TOWN OF CARMEL
PLANNING BOARD

PLANNING BOARD AGENDA
MARCH 14, 2024 – 7:00 P.M.

| 6. | Veolia (formerly Suez) Water – Mahopac Wells | 75.20-2-68 | | 1/19/24 | Site Plan |

The following is our response to Patrick Cleary, AICP, CEP, PP, LEED AP of Cleary Consulting, letter dated February 8, 2024:

PFAS COMPLIANCE AT
MAHOPAC WELL

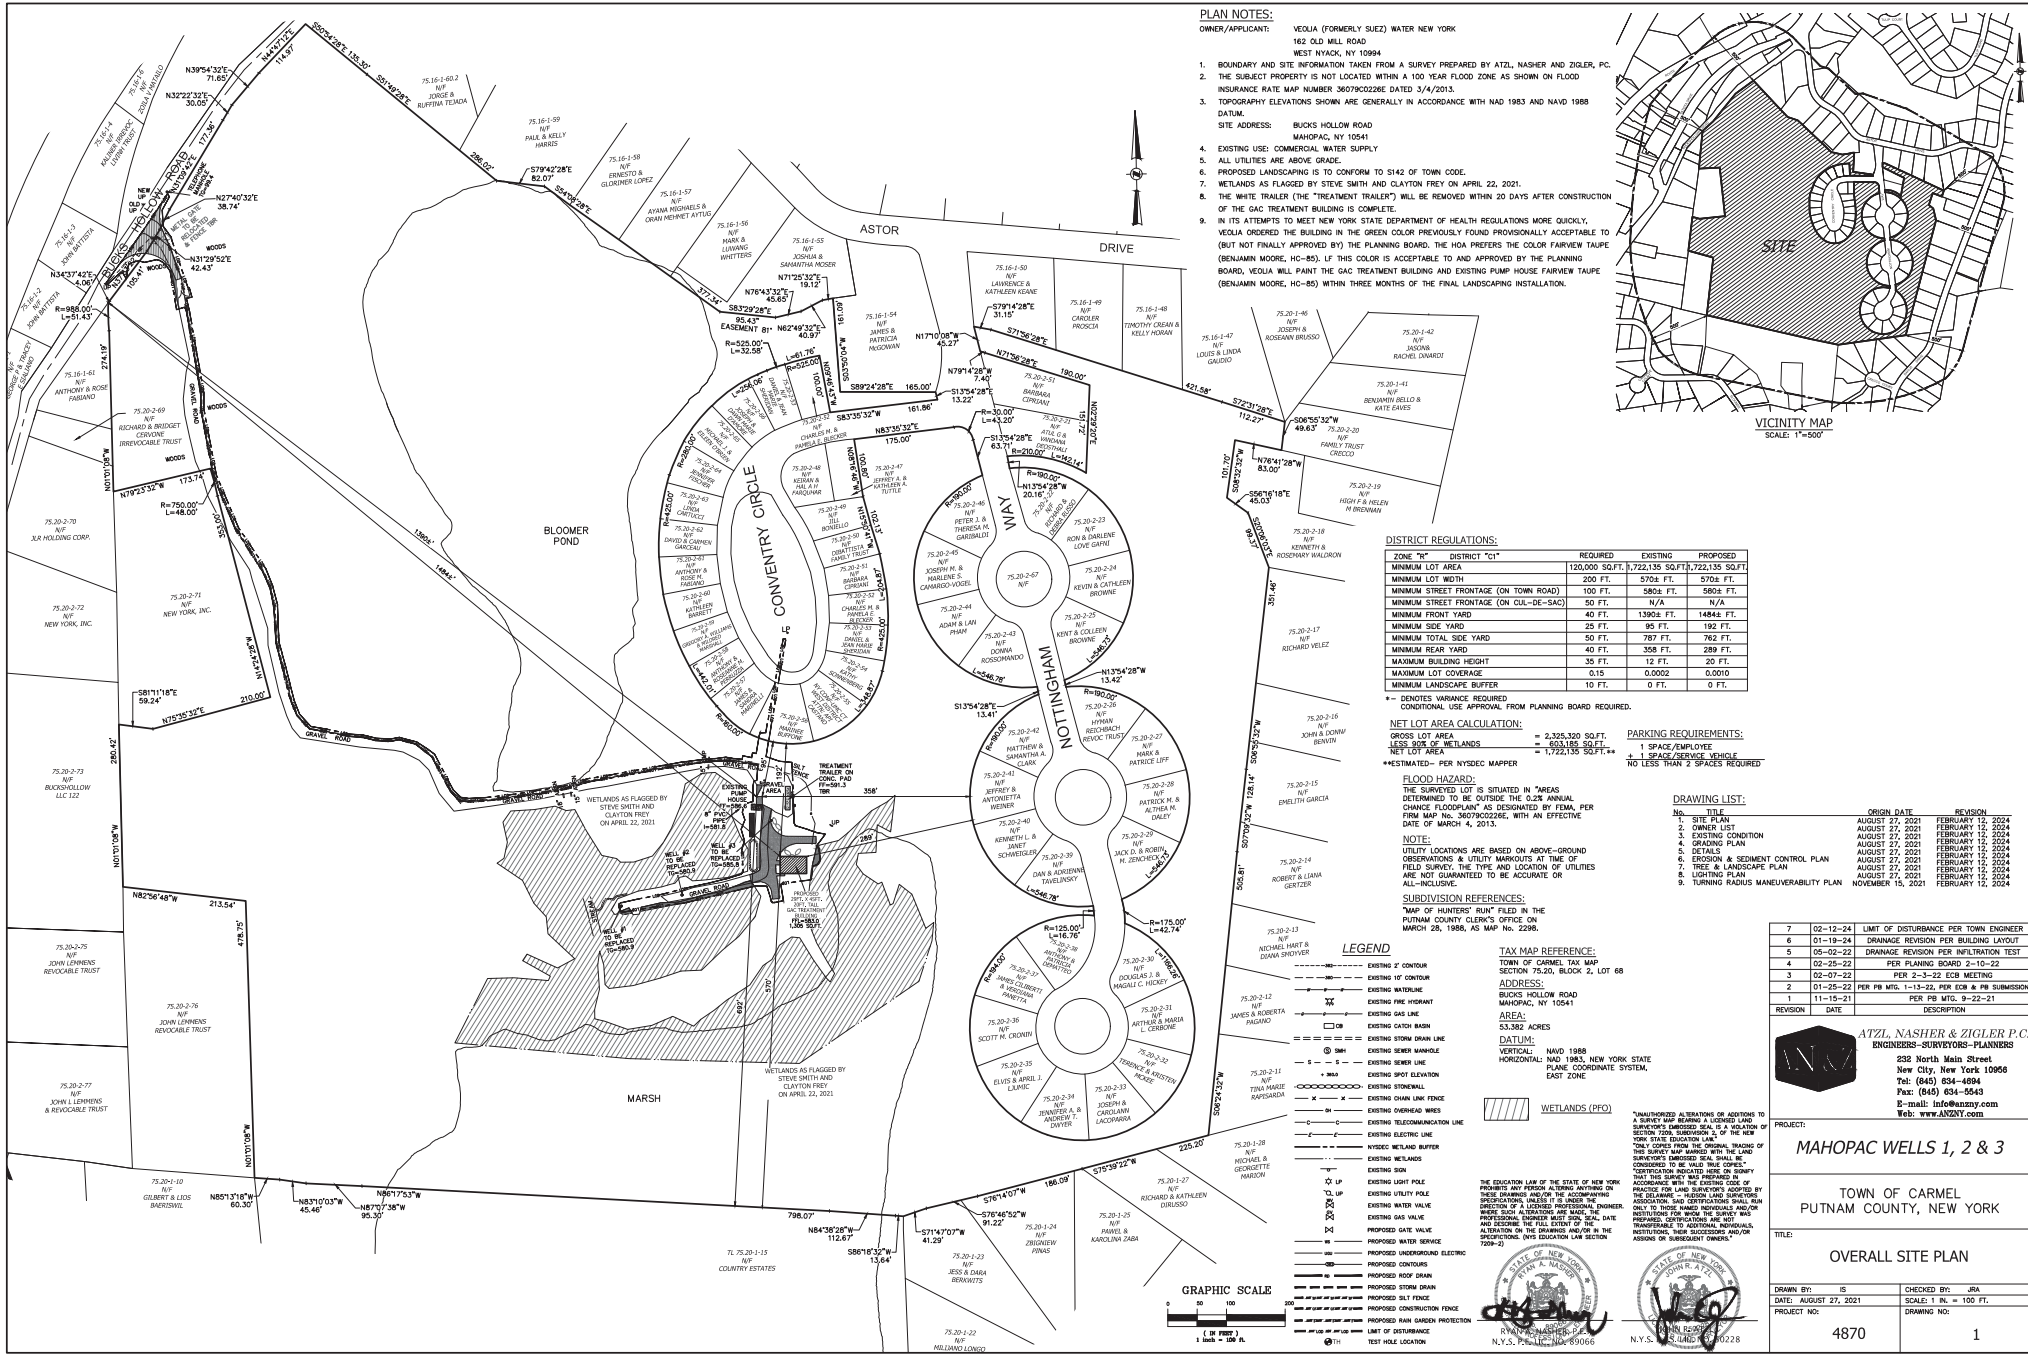
1. Comment: Code §156-37C requires "A landscaped buffer area at least 10 feet in width and six feet in height shall be provided and maintained along all property lines to satisfactorily screen public utility substations and any other buildings from surrounding uses of land". The Planning Board should look

Response: A landscaped buffer has been provided and maintained along property lines. The revised landscaping plan has been developed based on input from the Planning Board and subsequent discussions and agreement with the HOA. We believe it adequately screens the proposed development. A photo package and associated renderings have been provided to substantiate the same.

Our view is also supported by the aerial photographic exhibit that is part of this submission, which demonstrates that the facility is separated from the nearest residence to the east on Nottingham Way by more than 300 feet of densely- wooded land. (It is also 192 feet from the boundary line of the closest residential lot fronting on Coventry Circle). Veolia, therefore, requests that under Section 156-37(g) of the Town Code the Planning Board grant a waiver from the landscaping requirement.

PROJECT: MAHOPAC WELLS 1, 2 & 3

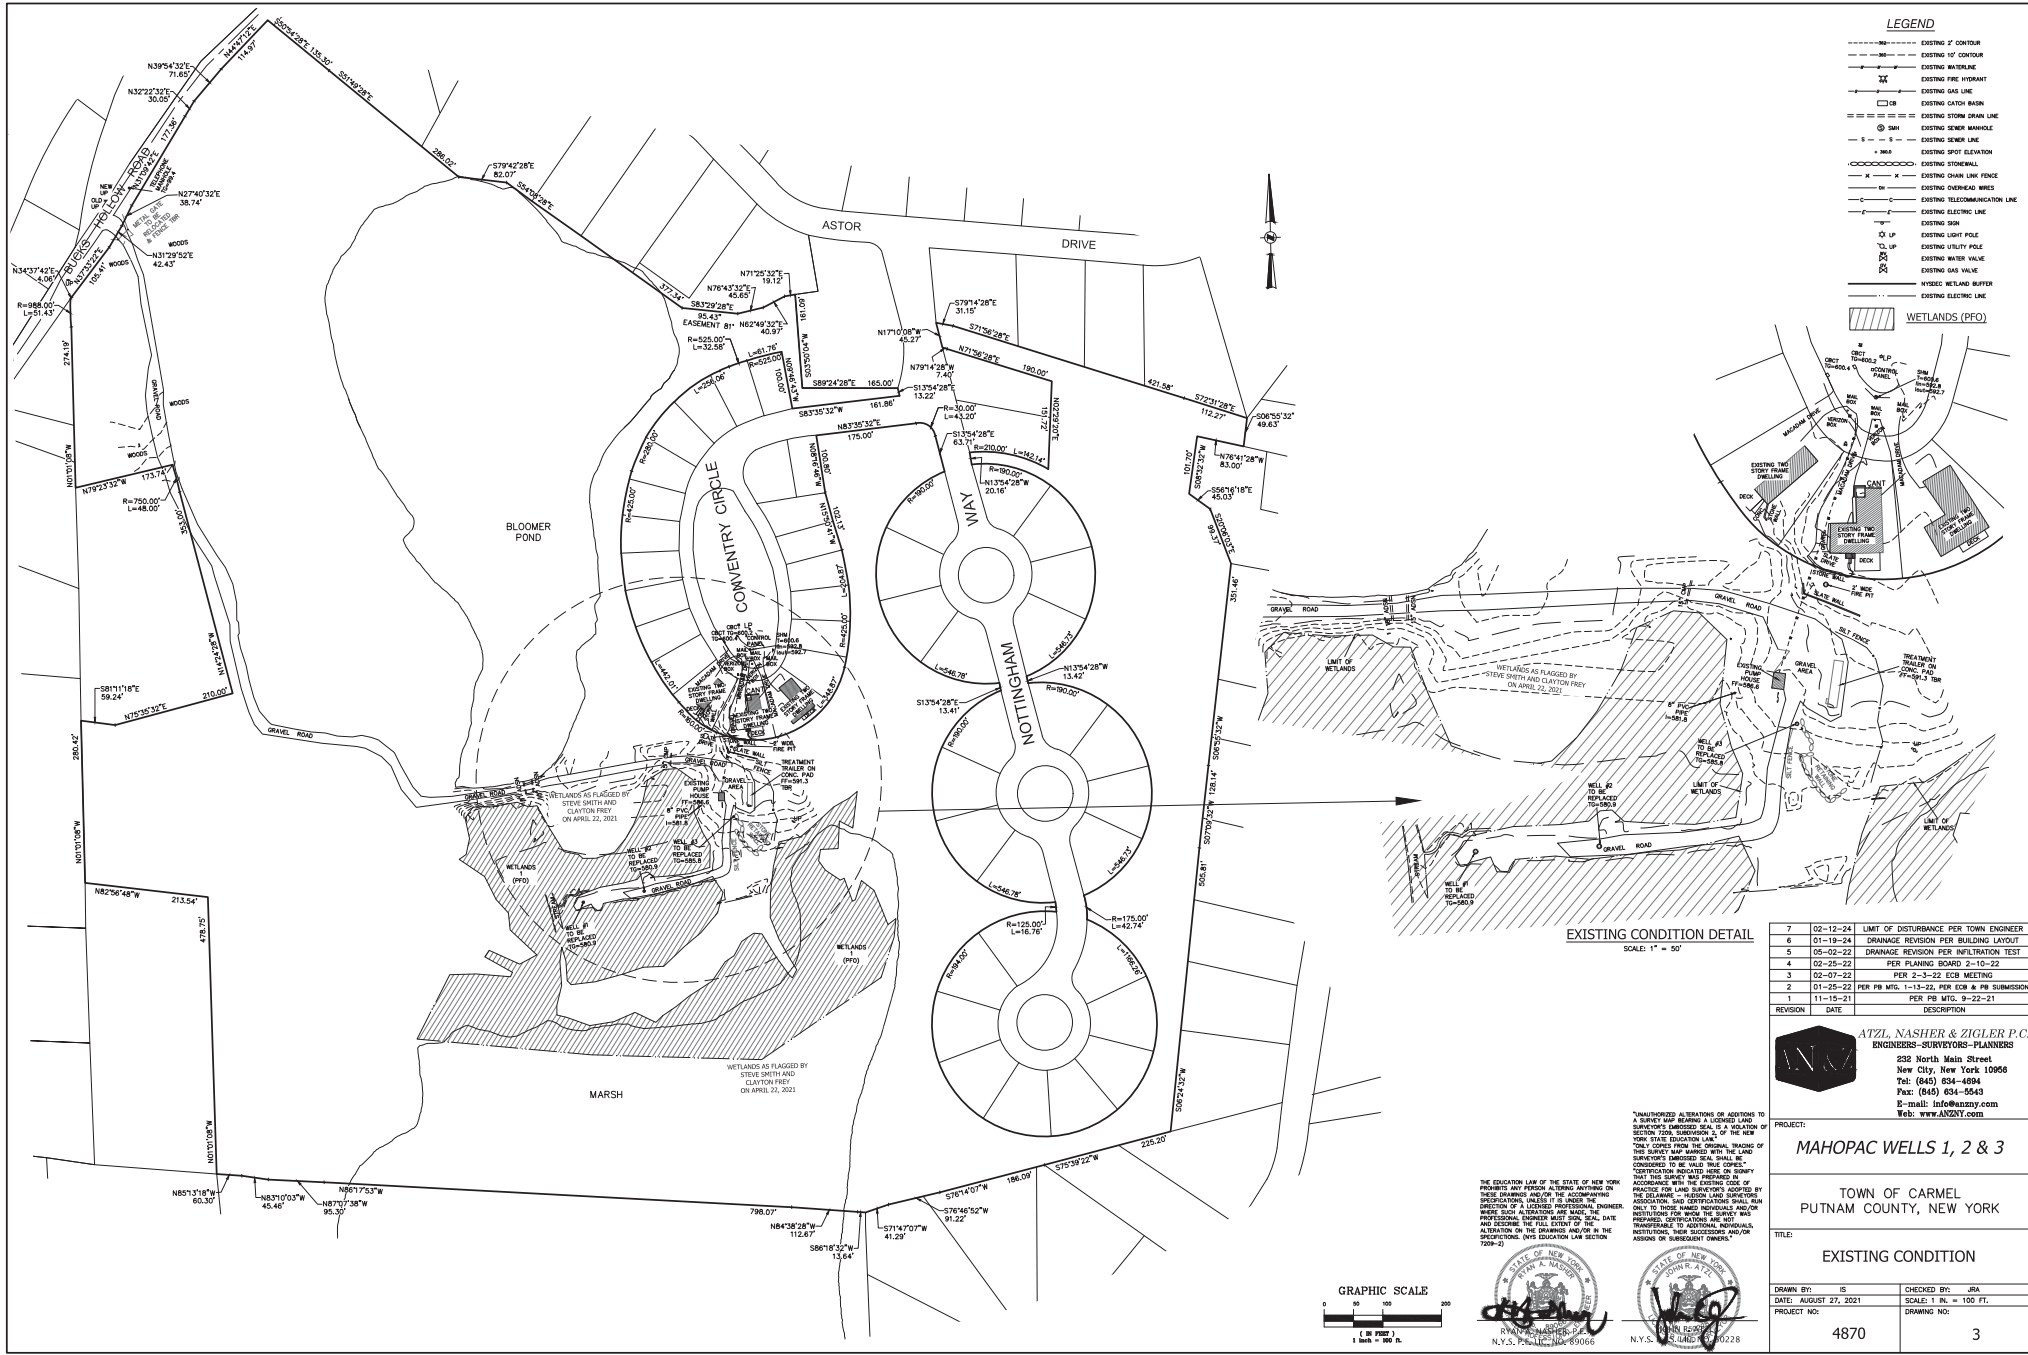
5. Comment: Identify the location of the emergency generator.

Response: The new generator location is shown on the site plan (see sheet 4).
